Japan's Comment for ANNEX2
of Battery Durability GTR
@EVE56

30. May. 2022

“Lifetime” Temperature Measurement

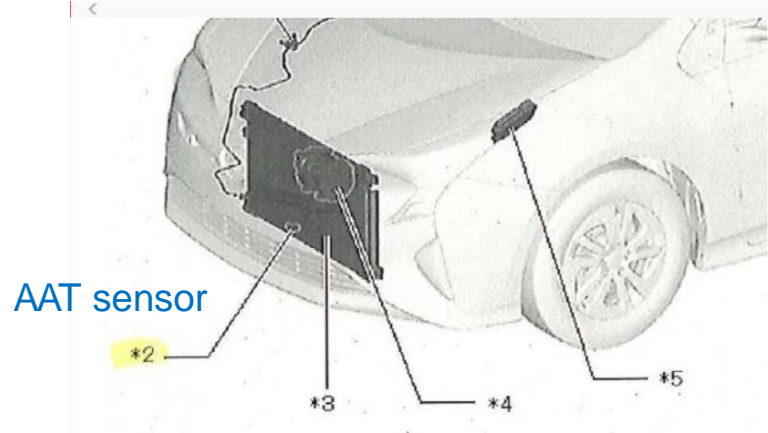
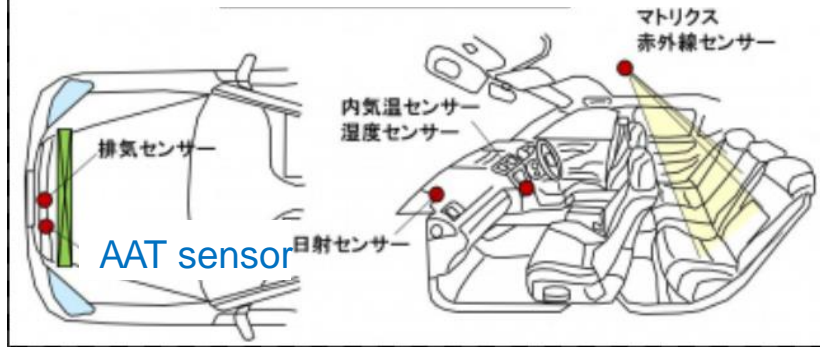
If the definition of lifetime includes IG-OFF time,

1. The measurement ECU, CAN-communication ECU, and data storage ECU must be operated at all times (or periodically wake up/sleep) while parked, which requires ***additional electrical energy** consumption (12 V battery dead, decrease in EV range, etc.).
2. There would be a high possibility of gaining ***abnormal values and error factors** in measurement during parking. This is because the position of an ambient air temperature sensor (AAT sensor) is often located around the radiator in front of the vehicle in order to accurately measure the ambient air temperature during driving (See page 3).)

<Example of error factors in parking>

effects of direct sunlight, reflection of sunlight from the ground (road surface temperature), exhaust gas from other vehicles, snow, freezing, etc.

Considering the additional observations below, Japan proposes:

1. to re-visit and clarify the purpose of the lifetime temperature measurement; and
2. to discuss the definition of “lifetime” based on pros and **cons*** of whether the IG-OFF time should be included in the definition or not
